Meeting Minutes Transmittal/Approval

Unit Managers Meeting: Grout Treatment Facility
Westinghouse Office, Lacey, Washington
Meeting Held April 23, 1992

Engineering Change Notices (B-714-114, -117, -118, -119, -120, -121 & -122)

Ref Dwg.
H-2-77581

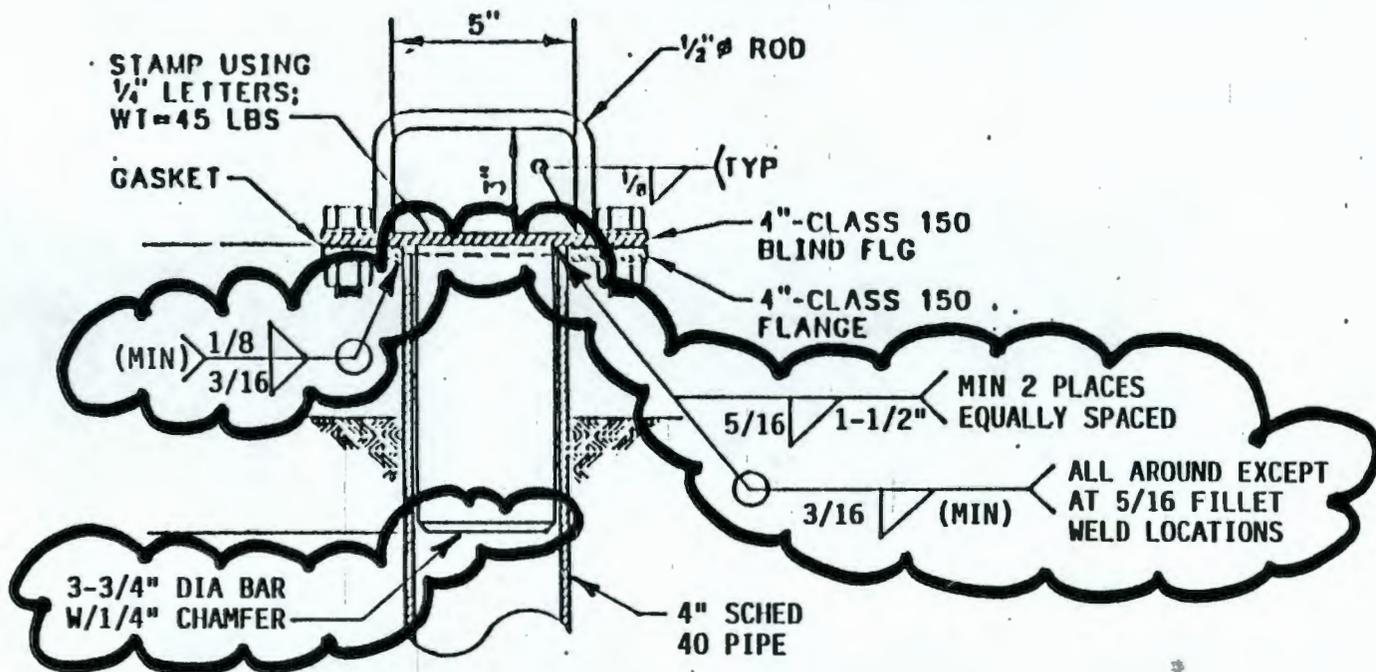
Detail 8 (Z C7): Modify as shown on page 4 of this ECN.

ARRANGEMENT PLAN

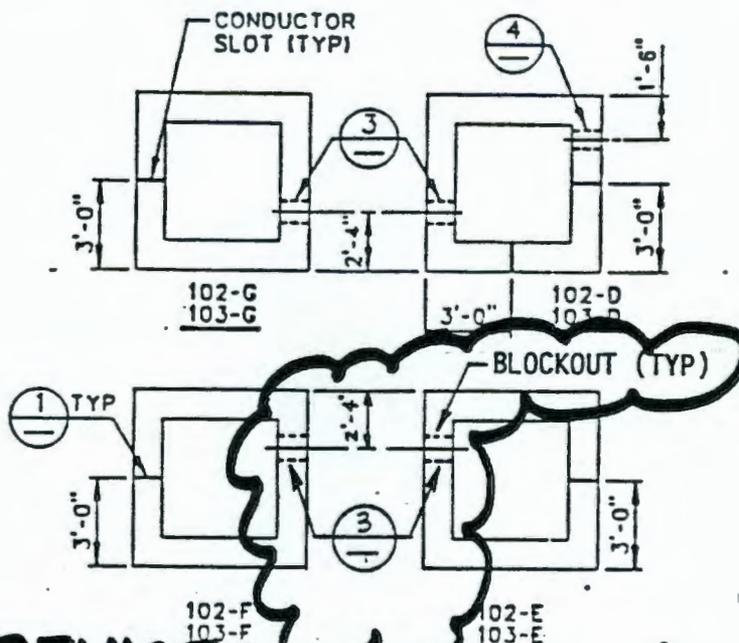
Arrangement Plan (Z C3): Relocate blockouts as shown on page 5 of this ECN.

COVER BLOCK PLAN NORTH

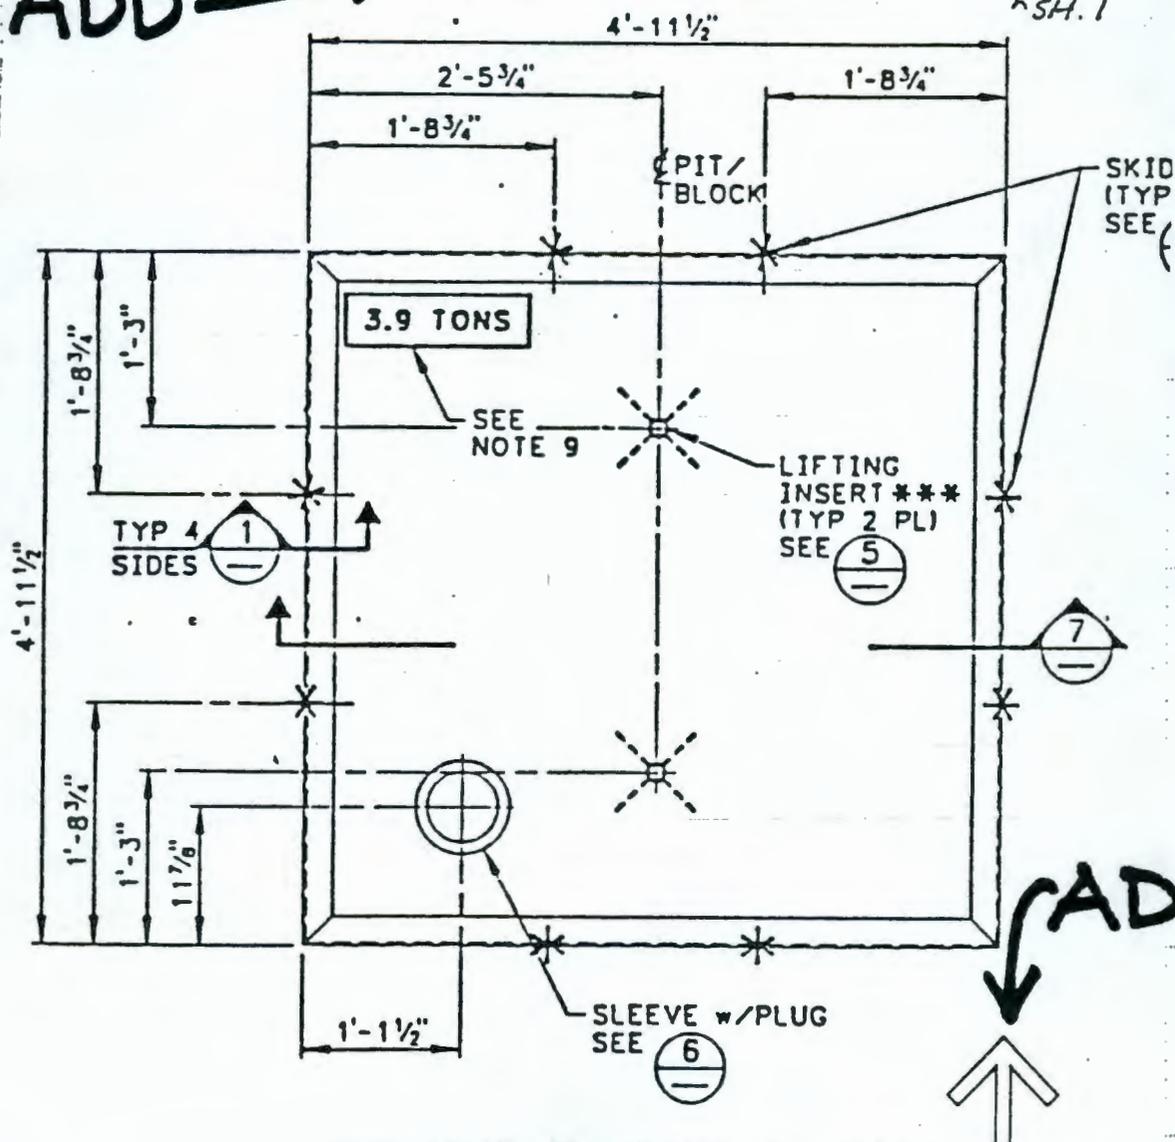
Cover Block Plan (Z F7): Reorient North arrows as shown on page 6 of this ECN.

Ref. Dwg. H-2-77581, DET 6	Sh. 2	Rev. 2	Prepared By G. Kow	Checked By M. Ataj 2/26/92	ECN No. B-714-117	Page 4/4
H-2-78457, DET 5	2	1

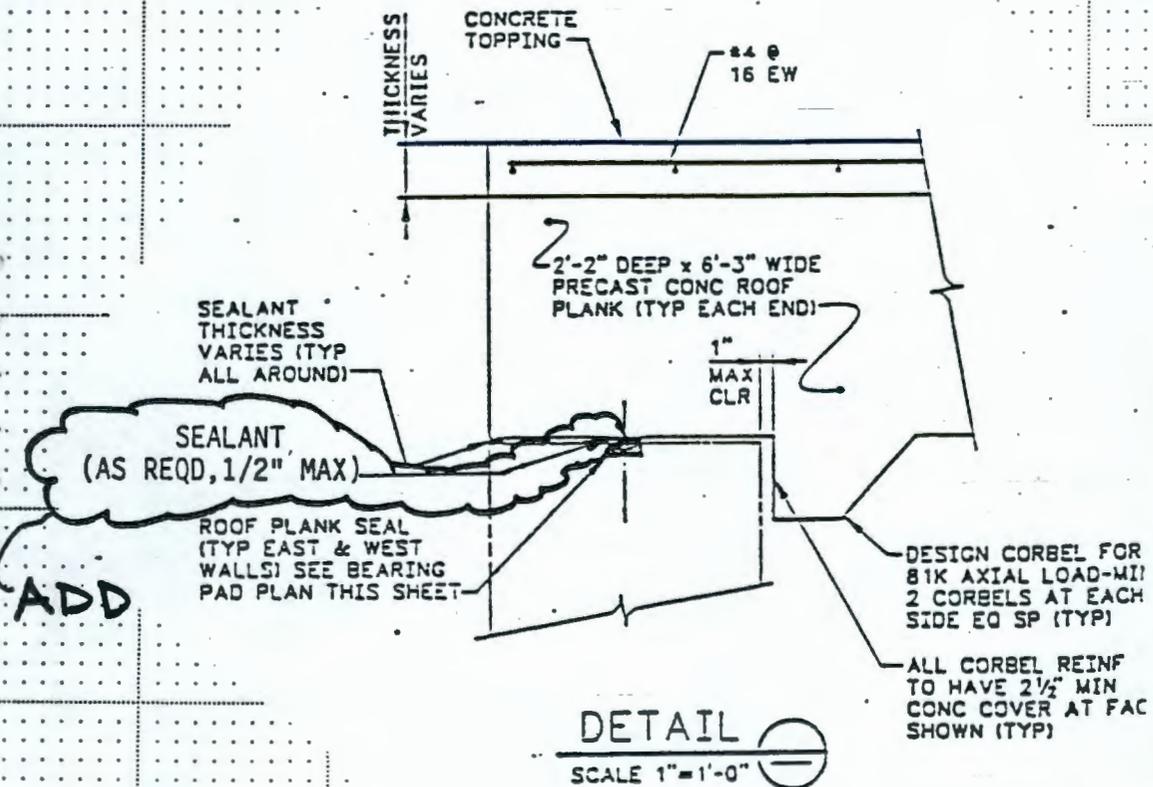
- A. Subparagraph 2.2.1.3, Replace first sentence with: Perform welding in accordance with AWS D 1.1, Section 8, using E70XX electrodes and complete penetration welds unless shown otherwise on drawings.
- B. Subparagraph Heading, Add: 2.2.2 Waterstop: Steel (Affects ECN B-714-91, Item 3b)

- 2) Drawings: H-2-77581, SH 2, Detail 6: REVISE DETAIL AS SHOWN ON PAGE 4
H-2-78457, SH 2, Detail 5: REVISE DETAIL AS SHOWN ON PAGE 4

DETAIL (3)

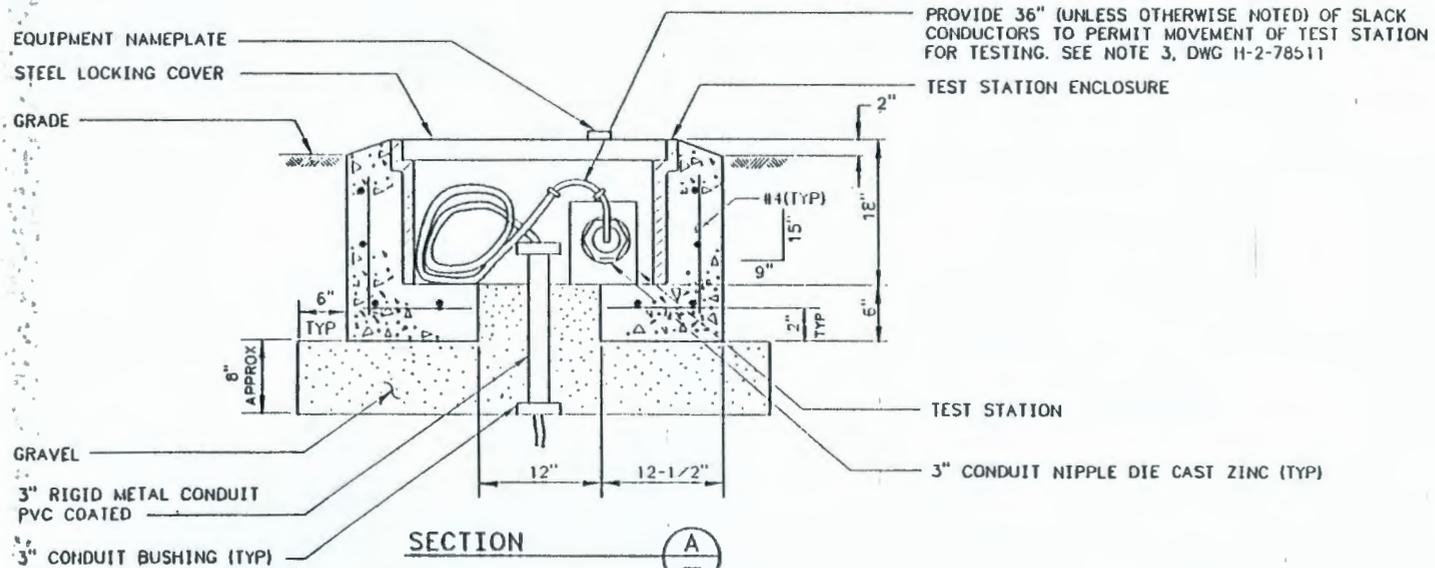
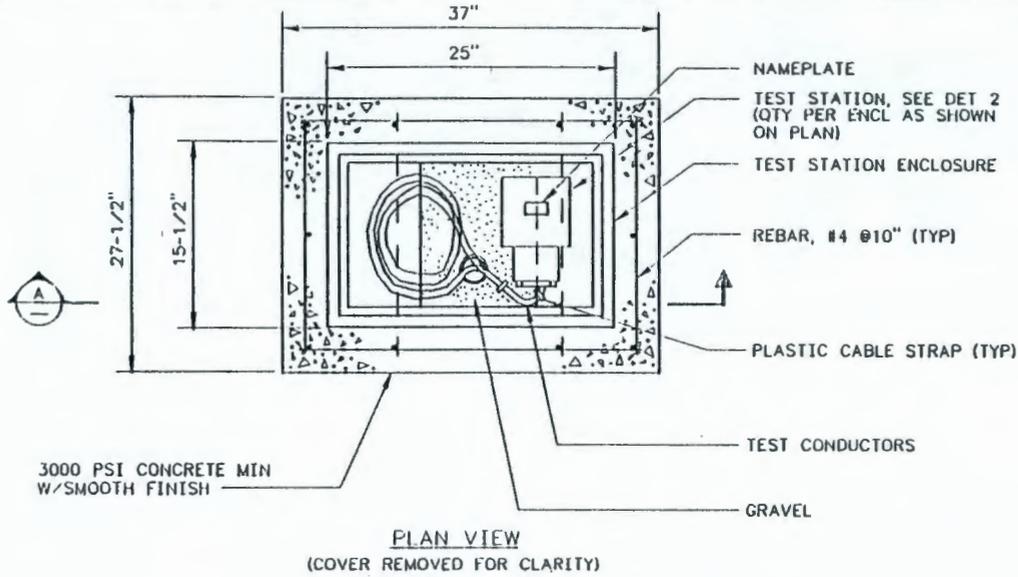
- 3) H-2-77645, Sh 1, Rev 1
Anode Location Table (Z B8): Change West Coordinate for A(45-5) to "W45896"
- 4) H-2-78512, Sh 1, Rev 1
Detail 3 (Z C4-F6): Replace - see page 4 of this ECN.

DETAIL 9

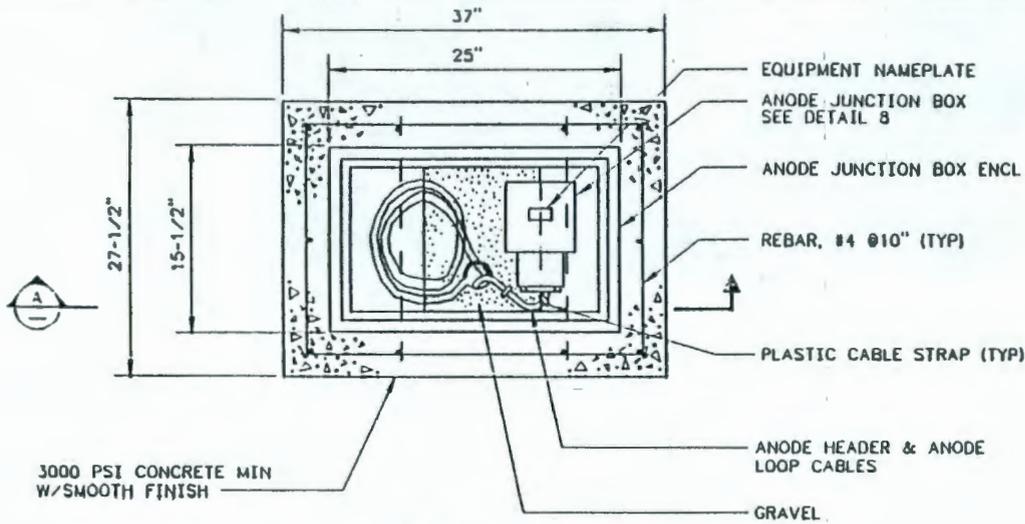
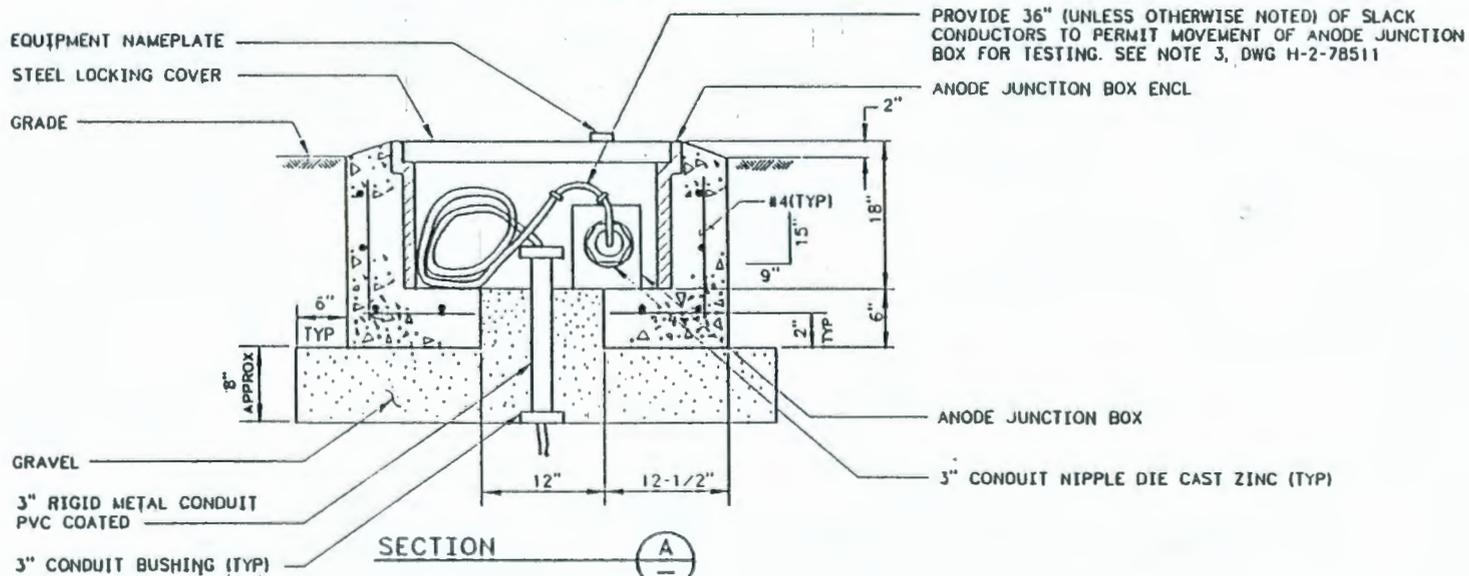
- 5) H-2-78513, Sh 1, Rev 1
Detail 9 (Z C4-F6): Replace - see page 5 of this ECN.
- 6) SPEC B-714-C2, SECTION 09805
 - A) Renumber para 2.1.1 to 2.1.2 and change to read:
Filler: Carboline 195 Surfacer.

DETAIL B

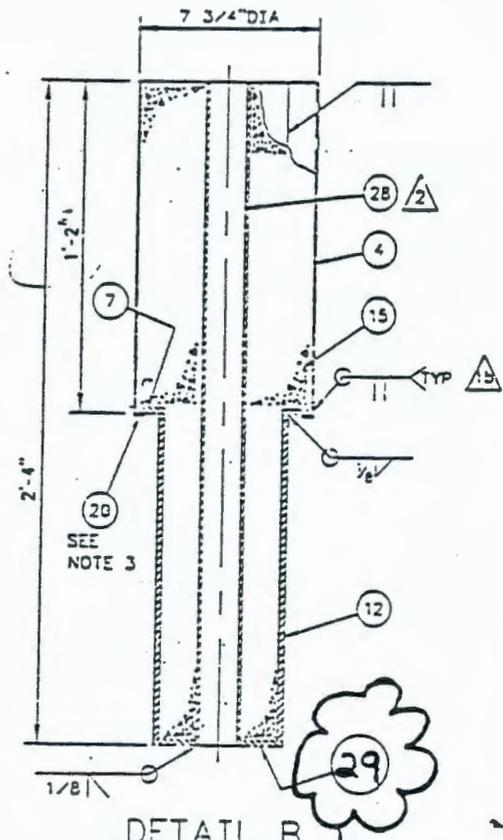
- A) Parts List: Modify - see page 4 of this ECN.
- B) Detail B (Z 5A): Revise callout for PN2 to PN29 as shown on page 5 of this ECN.
- C) Detail A (Z 5D): Add callout for PN30 at location of PN14 as shown on page 6 of this ECN.

- A) Parts List: Modify - see page 4 of this ECN.
- B) Detail B (Z 5A): Revise callout for PN2 to PN29 as shown on page 5 of this ECN.
- C) Detail A (Z 5D): Add callout for PN30 at location of PN14 as shown on page 6 of this ECN.
